International Isotopes Inc.

Subject: Submittal of Responses to Requests for Additional Information (RAI)
TAC L32739.

Fluorine Extraction Process &
Depleted Uranium De-conversion
Plant (FEP/DUP)

**Official Responses to
Environmental Report RAIs**

Figure 1-2 Projected IIFP Facility Estimated Annual Capacity

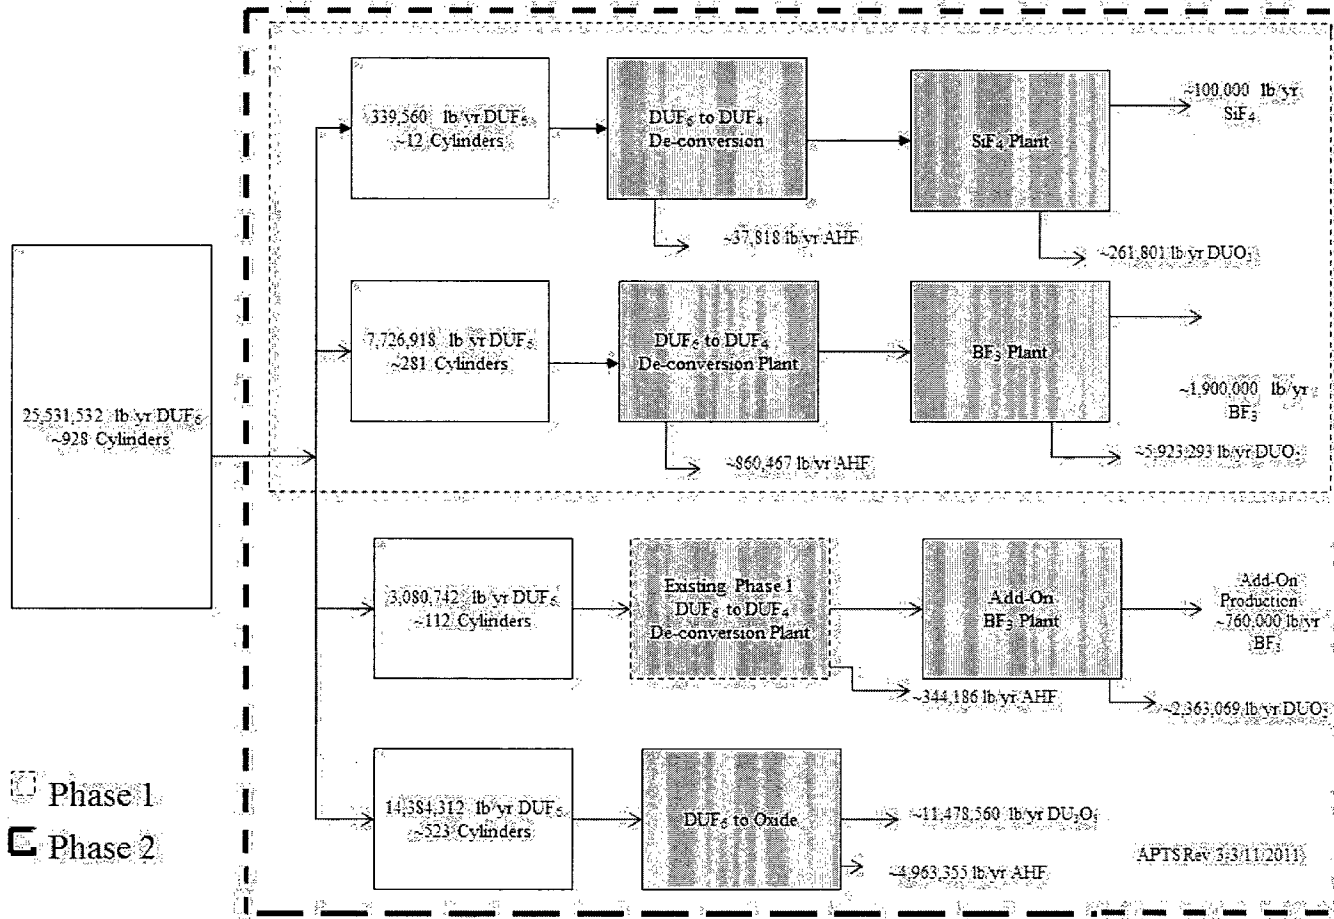
- b. *Provide separate quantitative Phase 1, Phase 2 (incremental), and cumulative (Phase 1 plus Phase 2) values for the following information described in Chapters 2 and 4 of the ER (IIFP, 2009a):*
- *all materials that serve as inputs and outputs to the deconversion process (a mass balance), including emissions and waste streams;*
 - *workforce; and*
 - *impacts.*

ER Figure 1-2 "Projected IIFP Facility Estimated Annual Capacity" will be removed and replaced to incorporate new calculations for an additional production line for BF₃ during the Phase 2 operations. Section 1.1 will be reviewed and revised accordingly. See also RAI 13a.

Environmental Report Documentation Impact: (1) ER Section 1.1 (renamed) will be revised beginning with former paragraph seven. Figure 1-2 will be removed and replaced with updated data. See also RAI ER-13a.) (1) Remove Table 1-1 and replace with renamed Table 1-1 “Phase 1 and Phase 2 Facility Inventories of Major Chemical Materials” in ER Section 1.2, renamed “Purpose and Need for Proposed License Action.” Section 1.2 will also include minor revisions to clarify Phase 1 and Phase 2, and to identify the values in Table 1-1; the section will read as follows:
